# REPAIRS TO FUELING PIER 170

## AKASAKI TERMINAL, SASEBO, JAPAN

DEPARTMENT OF THE NAVY
NAVAL FACILITIES ENGINEERING COMMAND
NAVAL FACILITIES ENGINEERING COMMAND
FISC, AKASAKI TERMINAL
SASEBO, JAPAN
REPAIRS TO FUELING PIER 170
TITLE SHEET

DRAWINGS REVISED TO INCLUDE THE REPLACEMENT OF BOLLARD P170–R

## FUELING PIER 170 SITE AND DEMOLITION PLAN

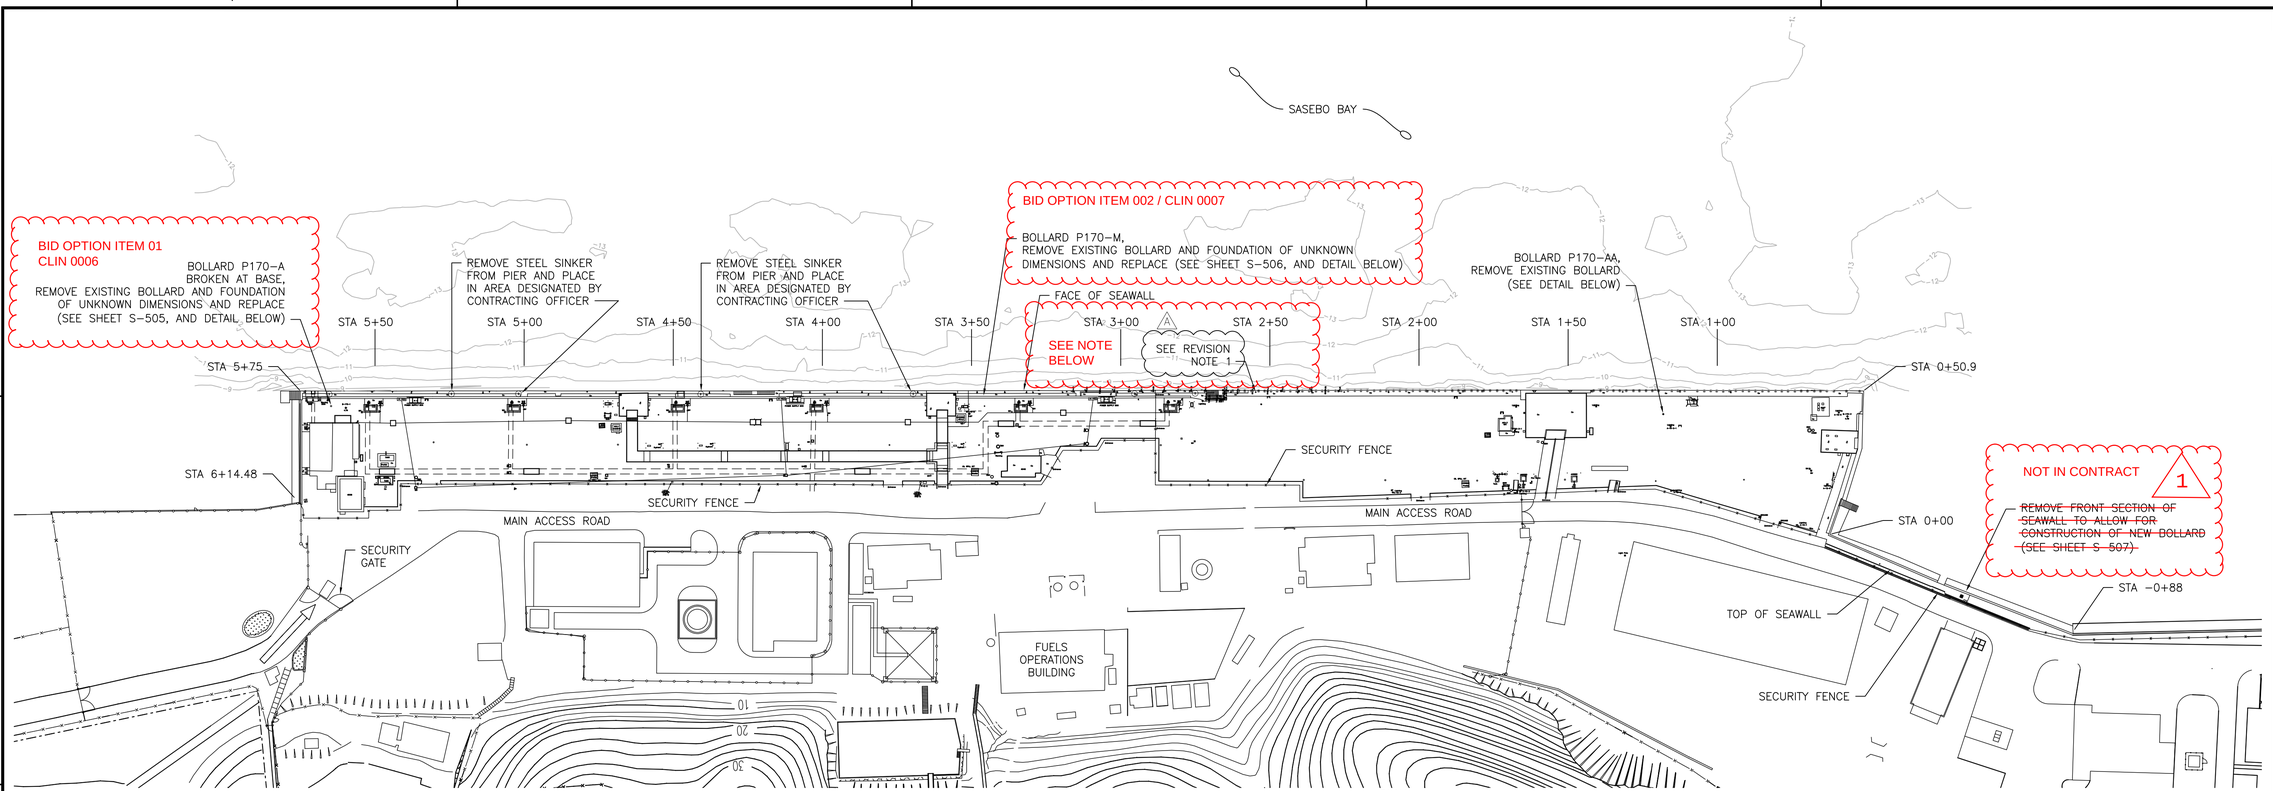
1. BOLLARD P170-R BROKEN AT BASE. REMOVE BOLLARD AND FOUNDATION OF UNKNOWN DIMENSIONS AND REPLACE, (SEE SHEET S-506 AND DETAIL BELOW).

# PIER 170 DECK PLAN

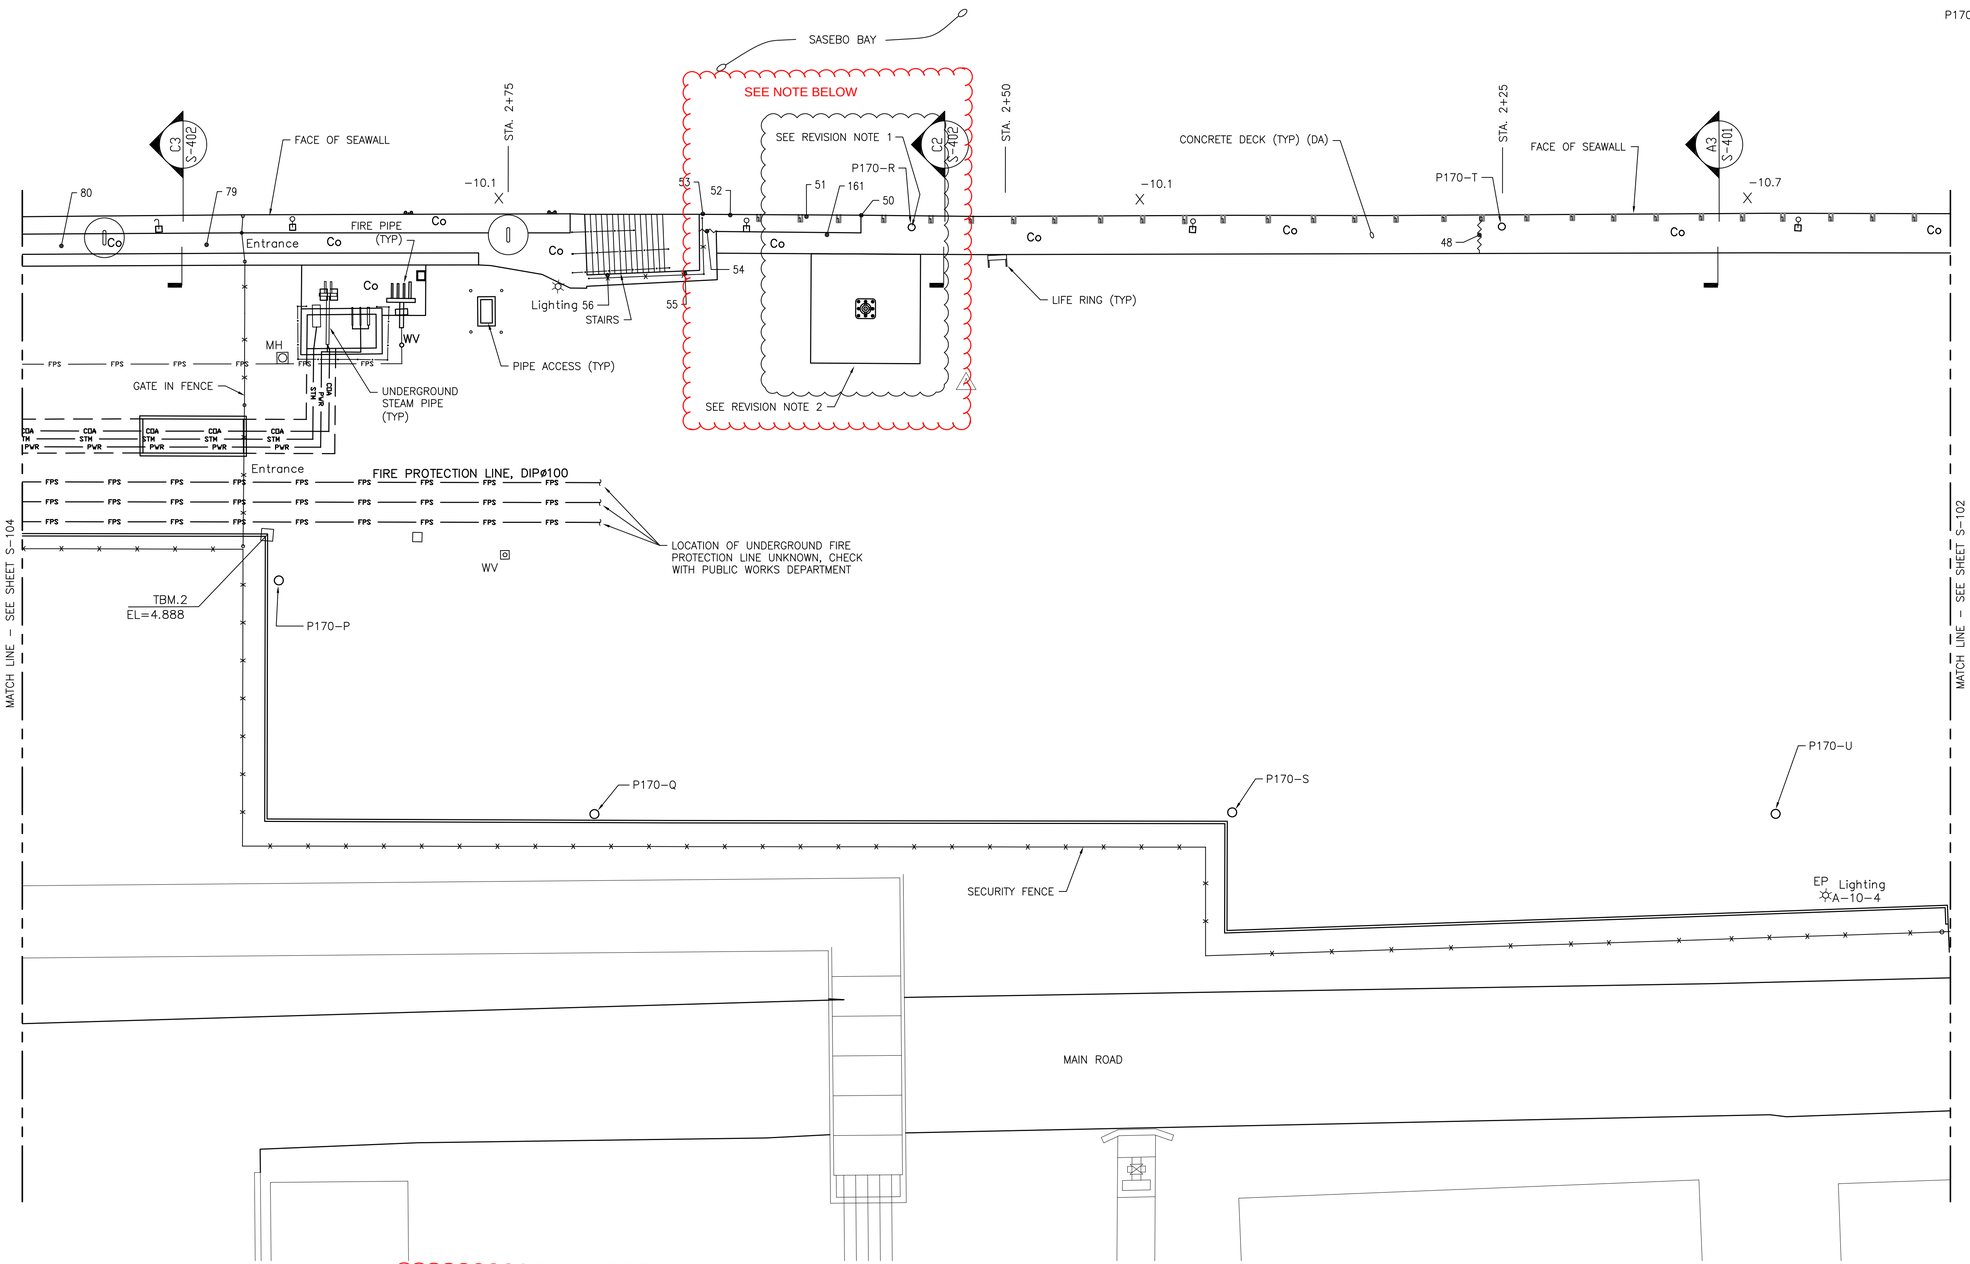
1. REMOVE EXISTING BOLLARD P170-R.
2. NEW BOLLARD SEE SHEET S-506

## BOLLARD P170-R REPLACEMENT PLAN

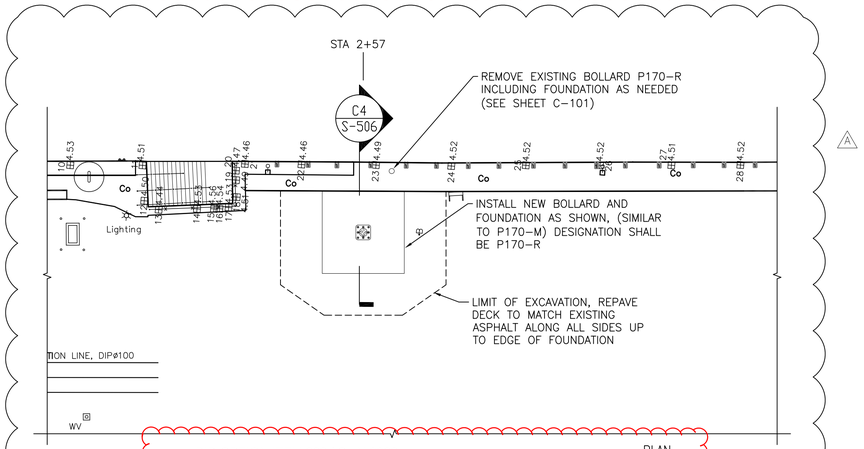
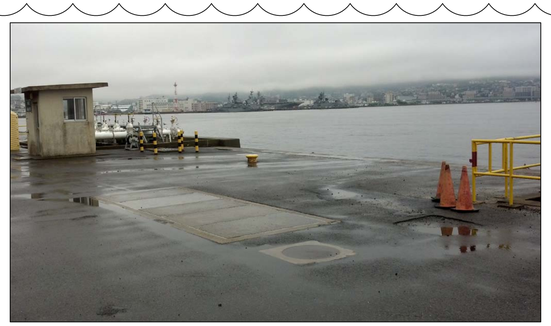
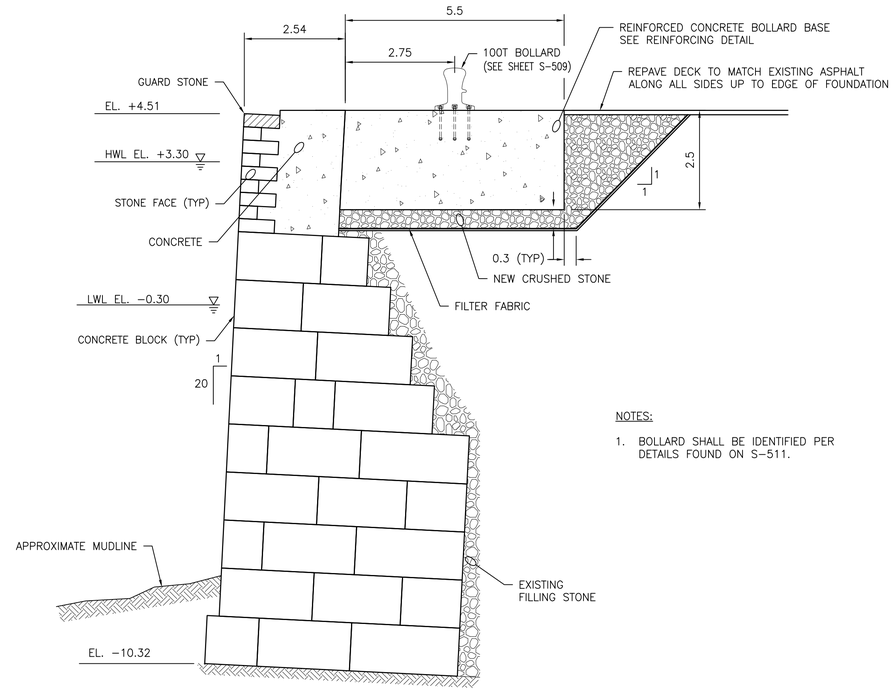
BID OPTION ITEM 003 / CLIN 0008

## BOLLARD P170-GG REPLACEMENT PLAN

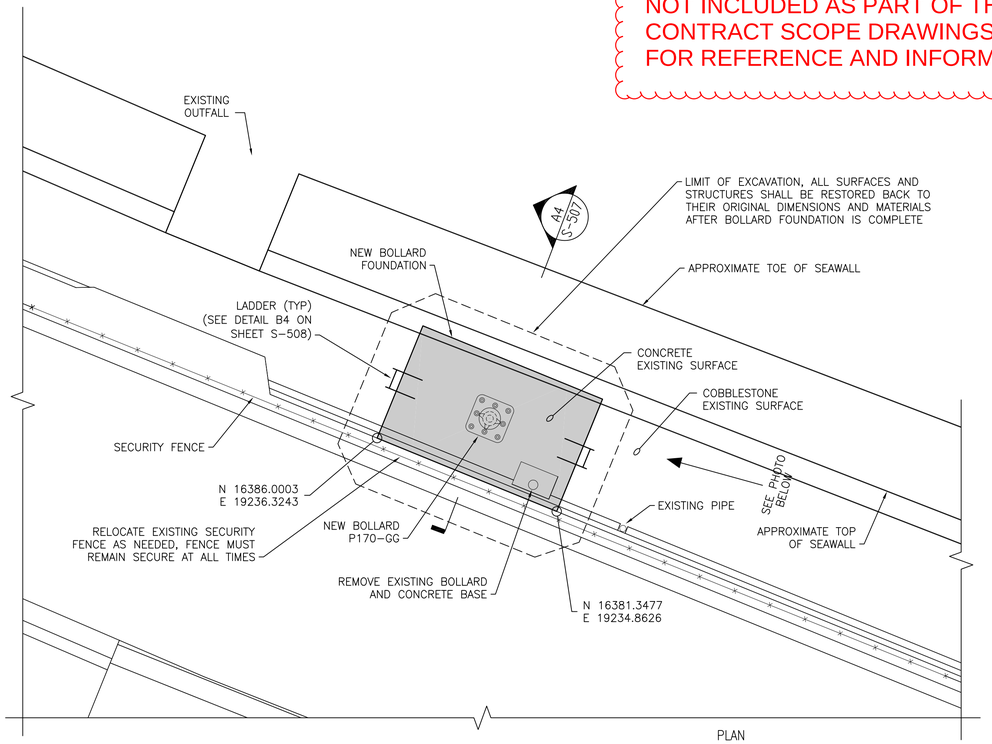
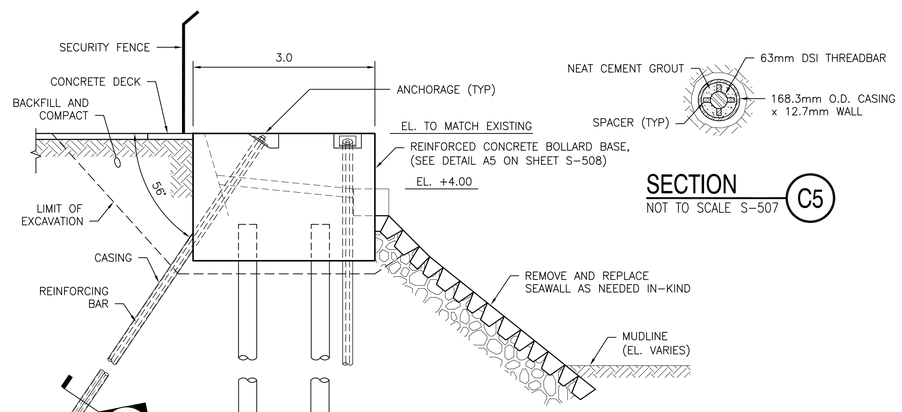
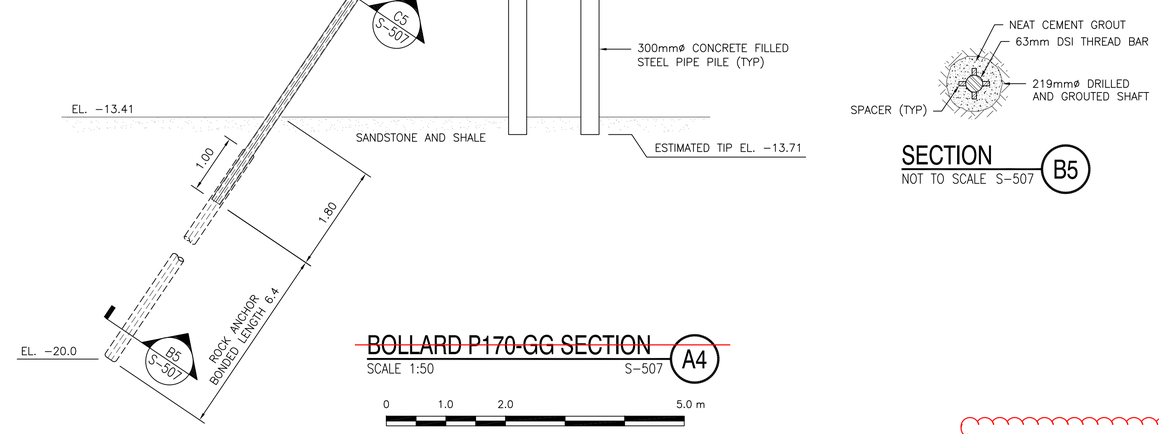
BOLLARD P170-GG REPLACEMENT IS NOT INCLUDED AS PART OF THIS CONTRACT SCOPE DRAWINGS ARE LEFT FOR REFERENCE AND INFORMATION ONLY. 1

## BOLLARD P170-GG DETAIL A5

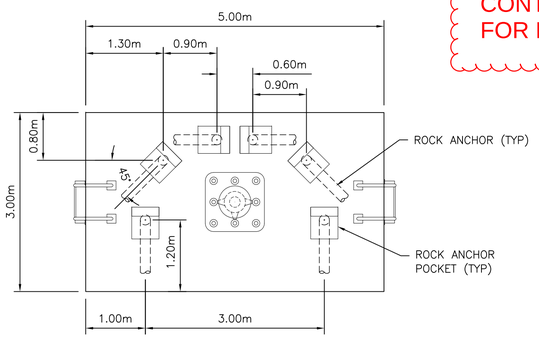
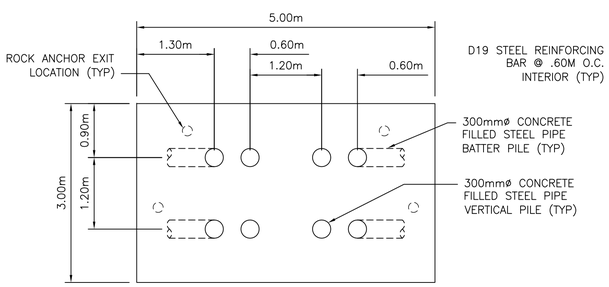
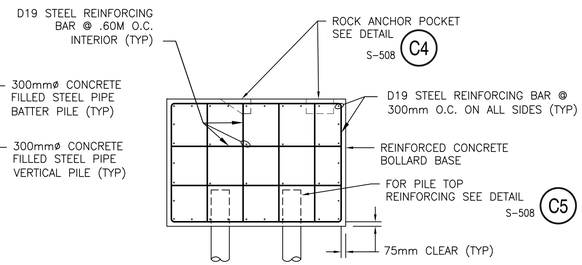
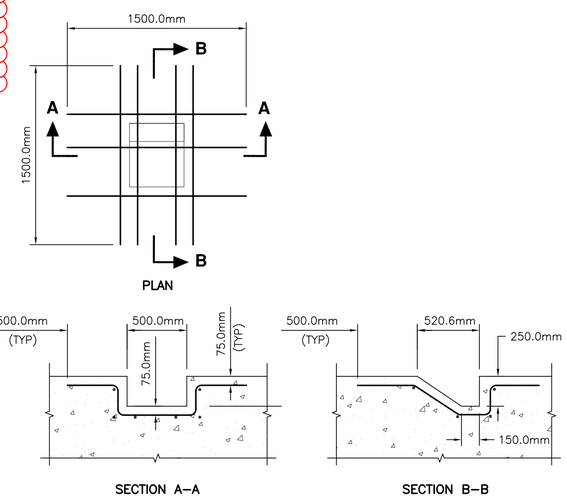
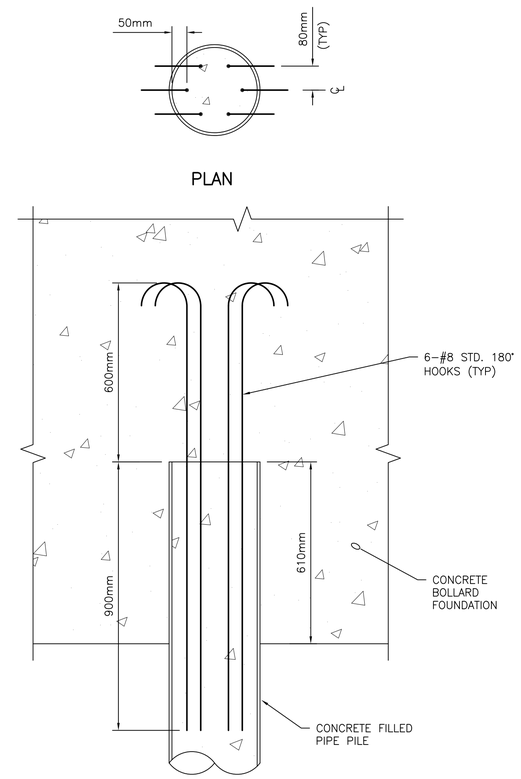
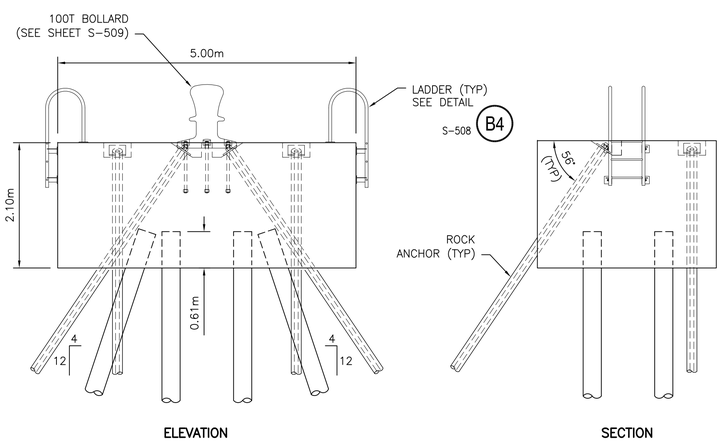
BOLLARD P170-GG REPLACEMENT IS NOT INCLUDED AS PART OF THIS CONTRACT SCOPE DRAWINGS ARE LEFT FOR REFERENCE AND INFORMATION ONLY. 1
